CONSTRUCTION PLANS
FOR
THE RIDGE AT LORSON RANCH FILING NO. 2

STREET & STORM SEWER CONSTRUCTION PLANS

SF 22-005

**THE RIDGE AT LORSON RANCH FIL NO. 2
STREET & STORM SEWER
CONSTRUCTION PLANS**

STM LAT "O" PROFILE

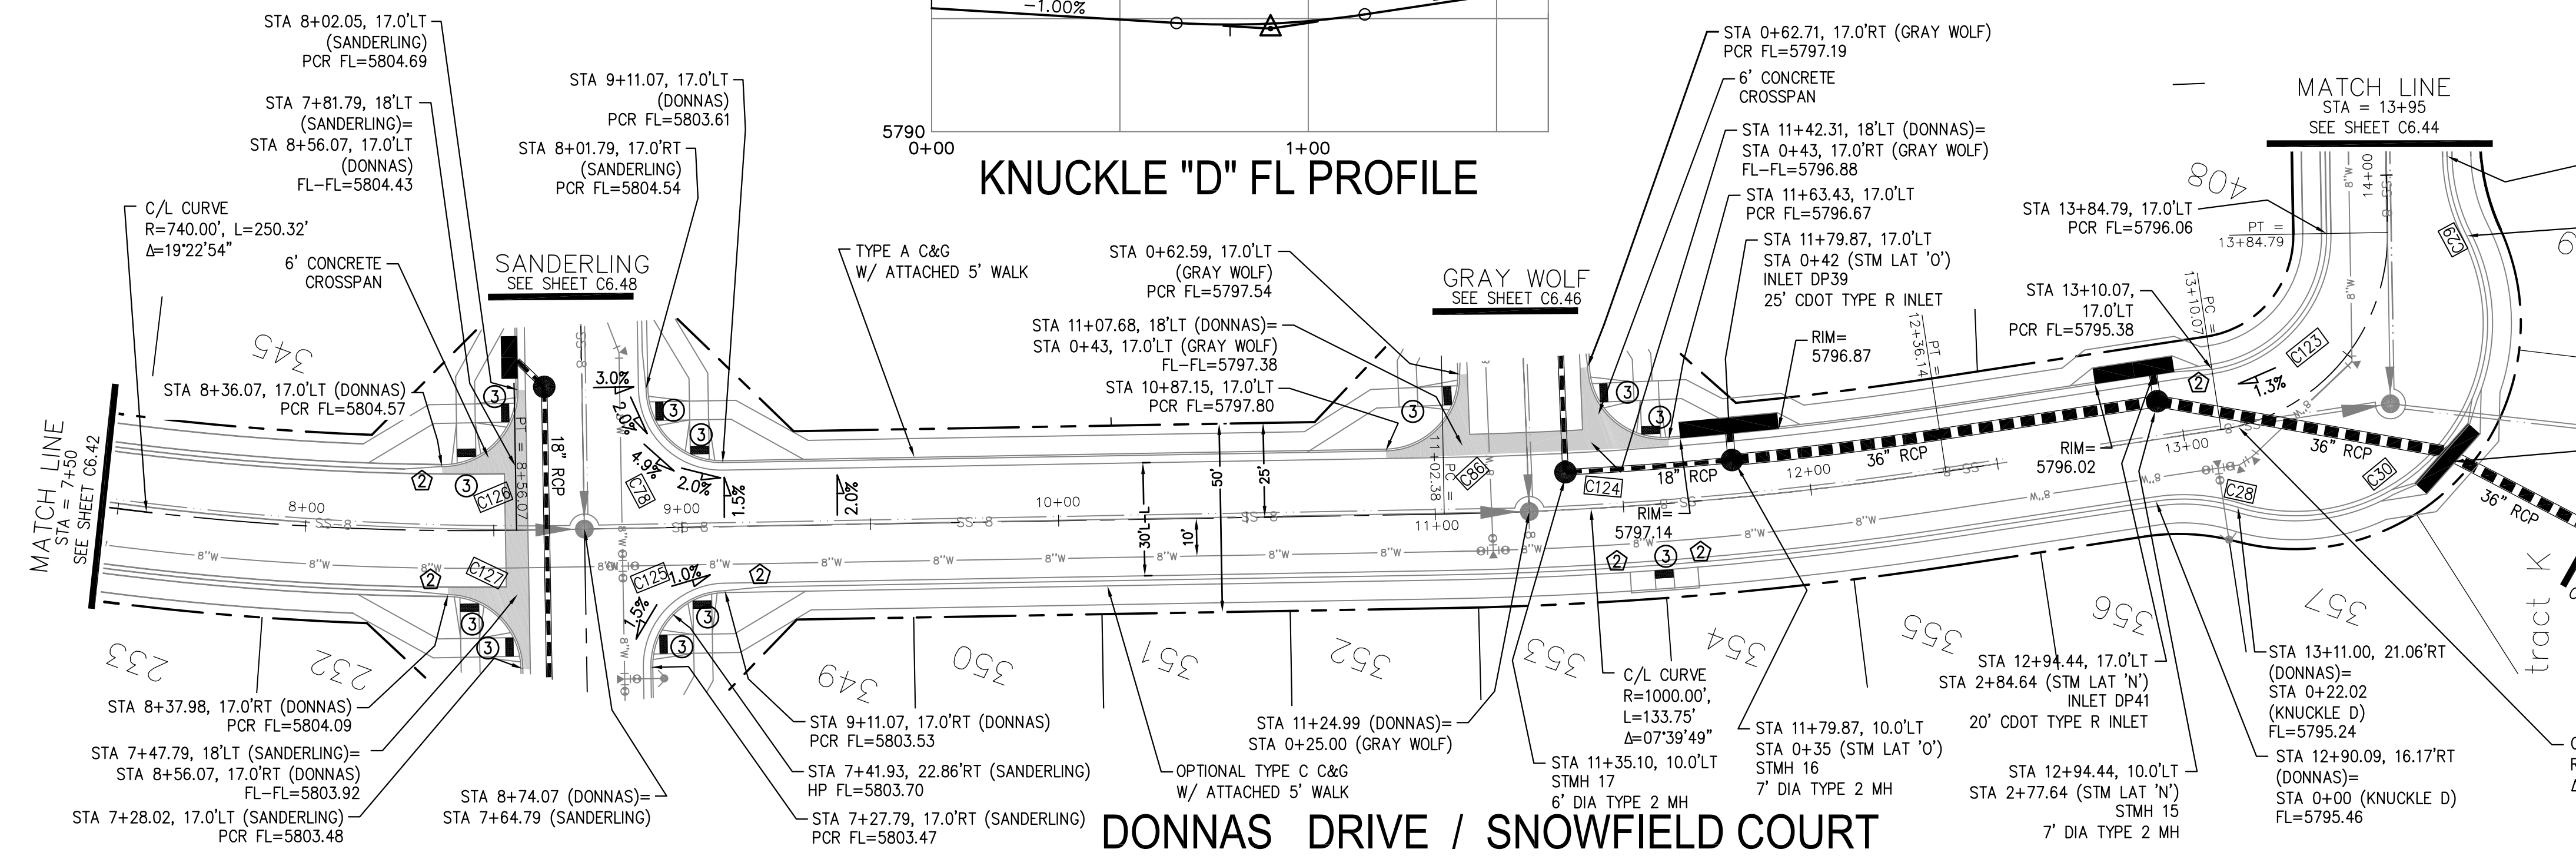
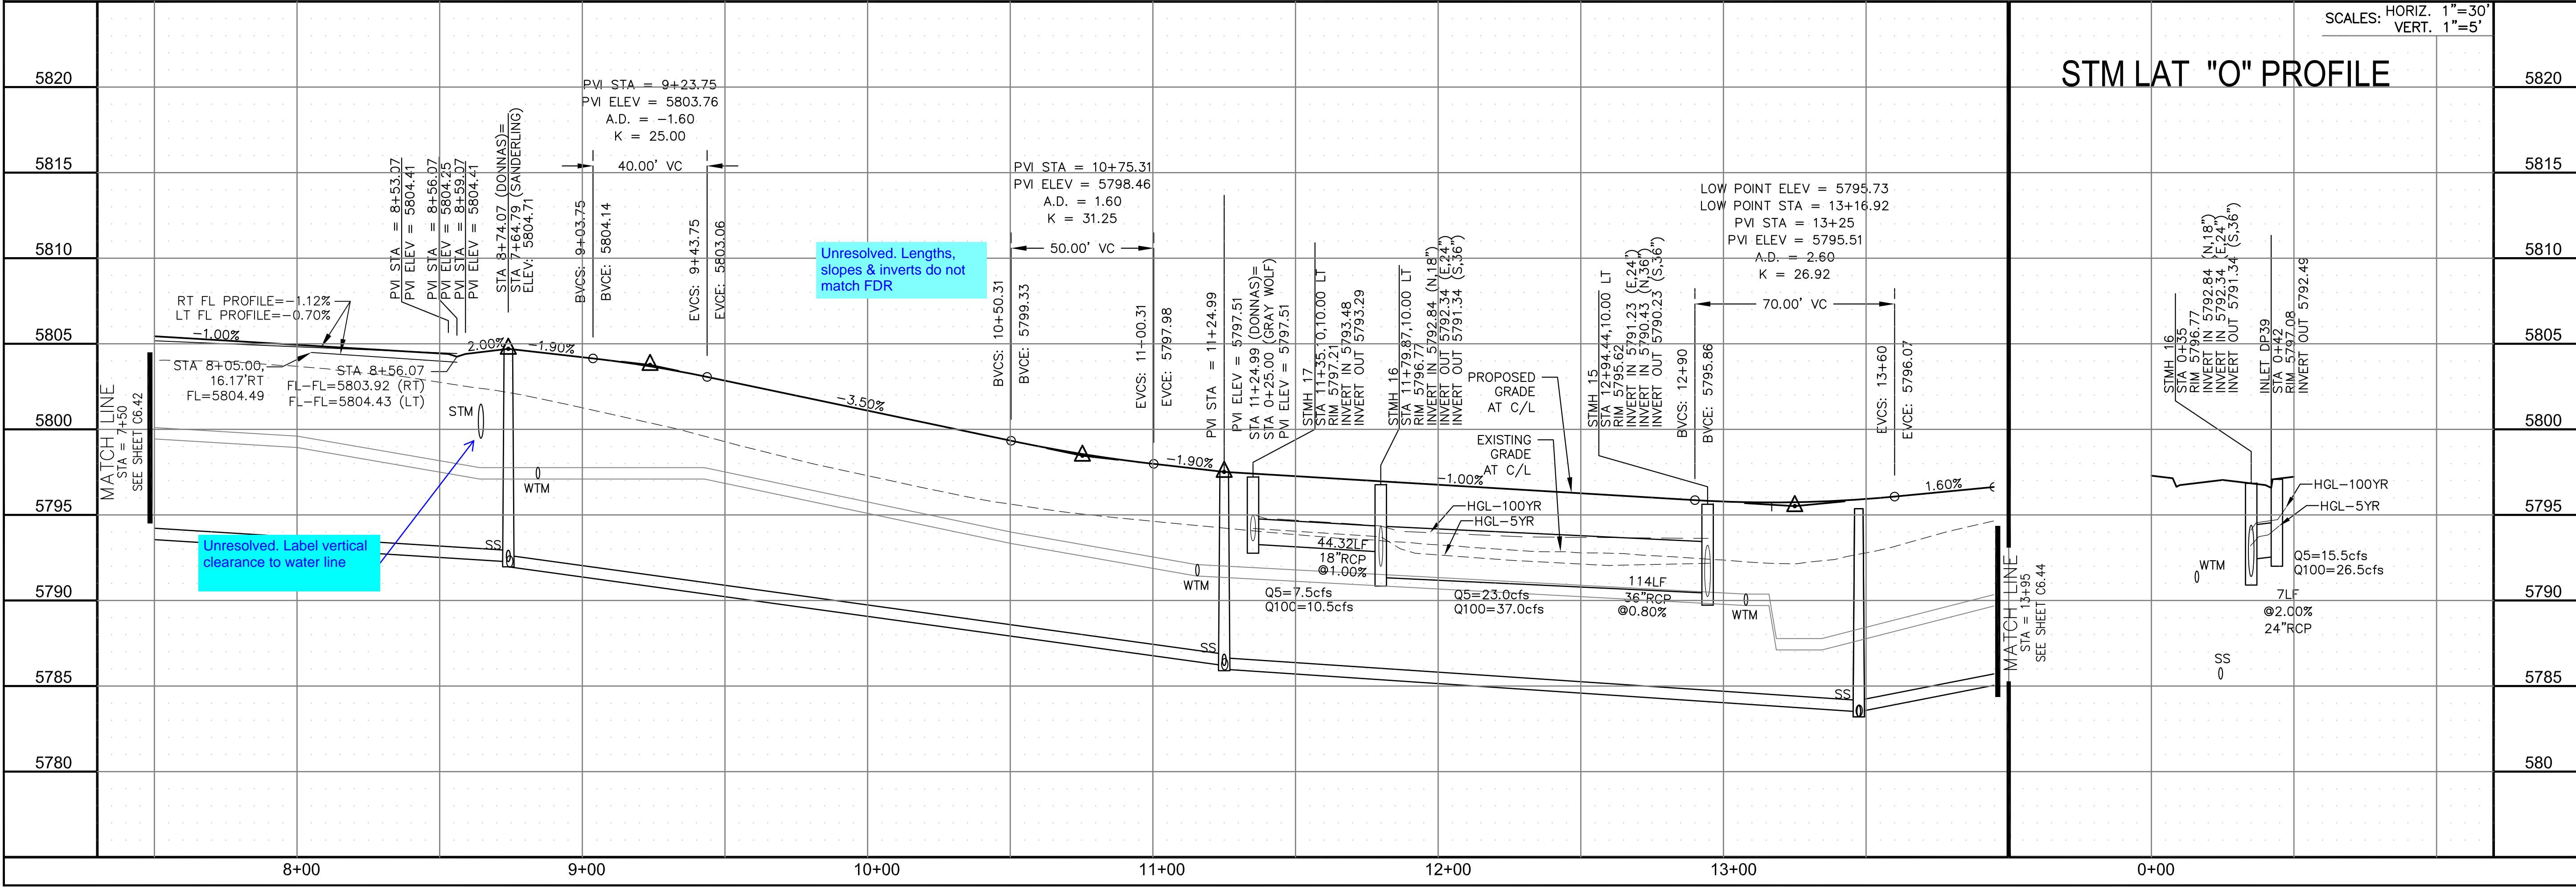
Unresolved. Lengths, slopes & inverts do not match FDR

MERIDITH RIDGE WAY

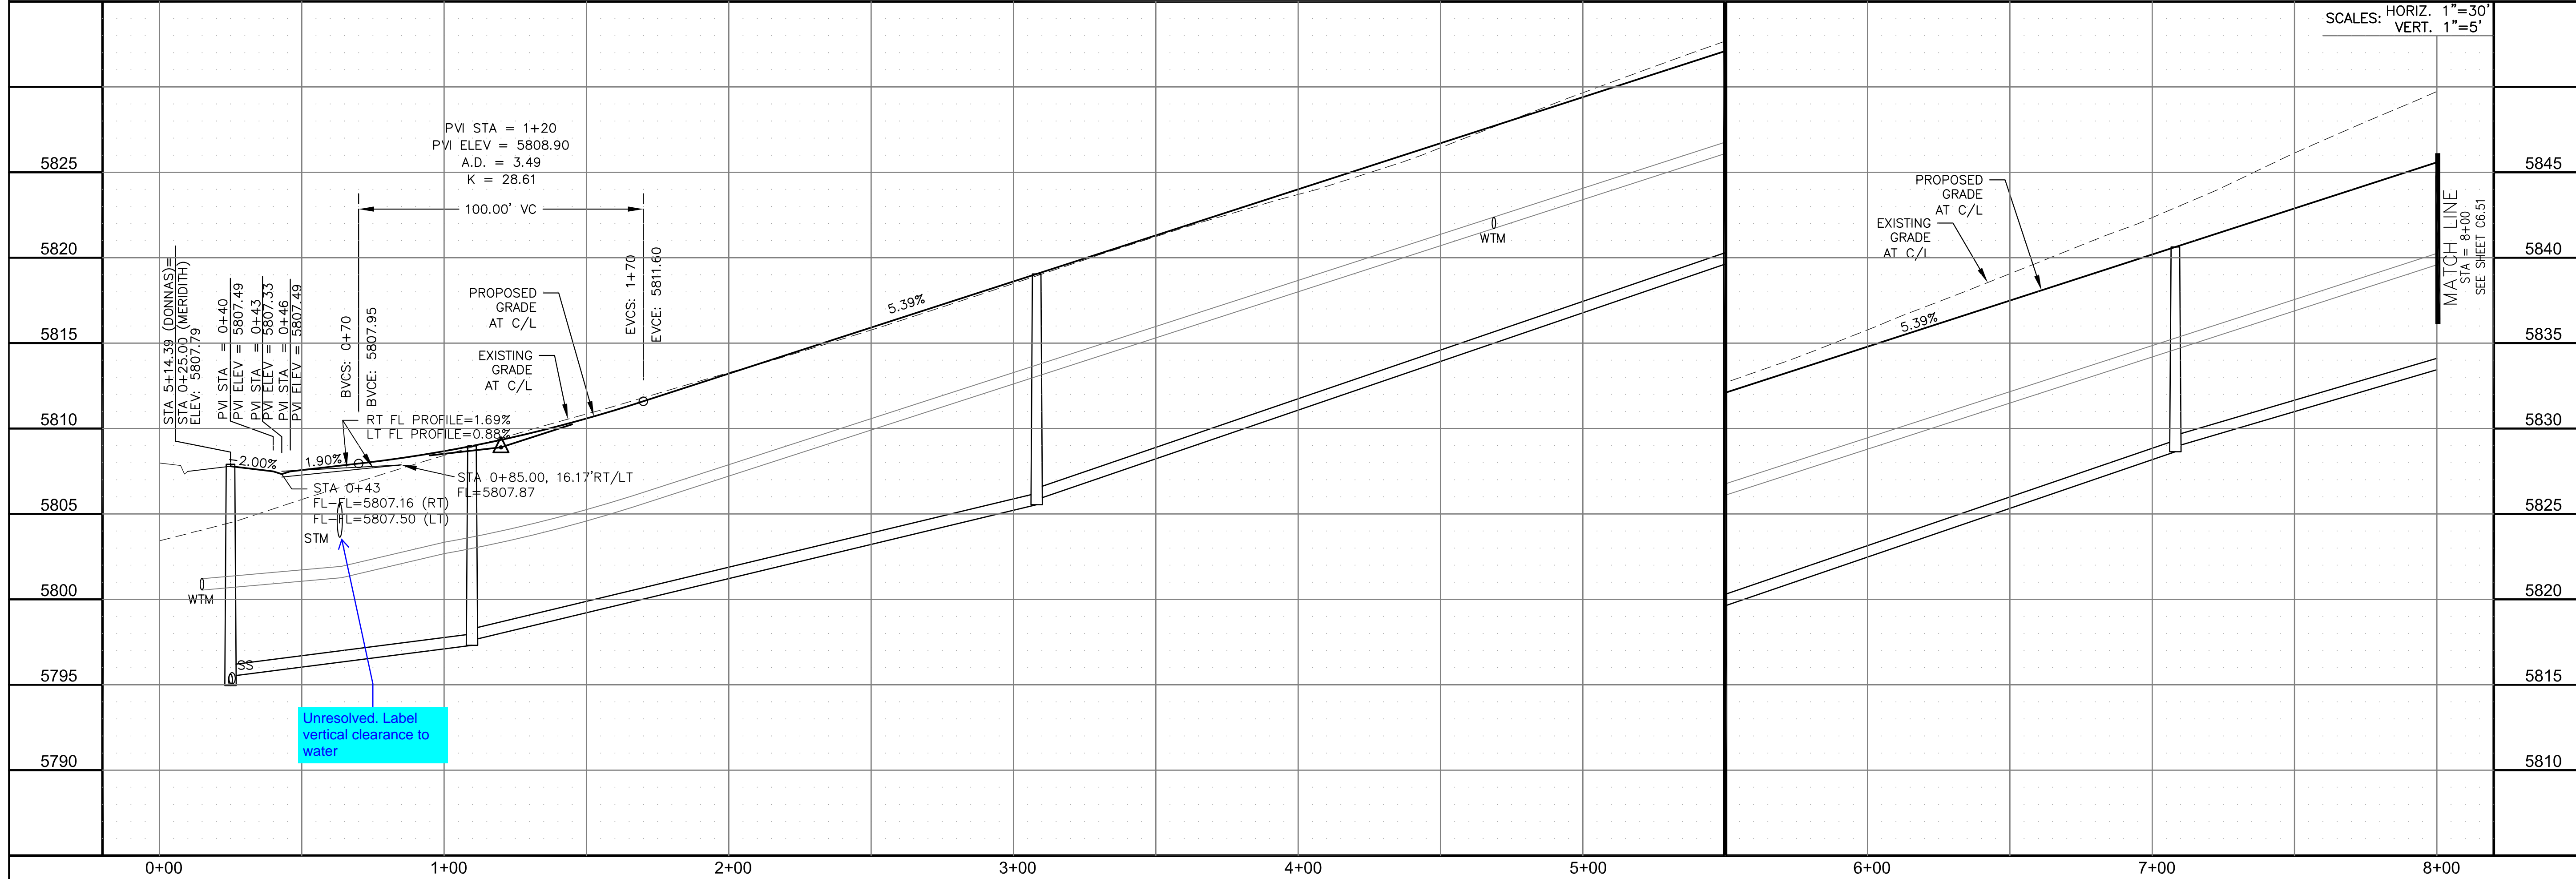
Unresolved. Label vertical clearance to water
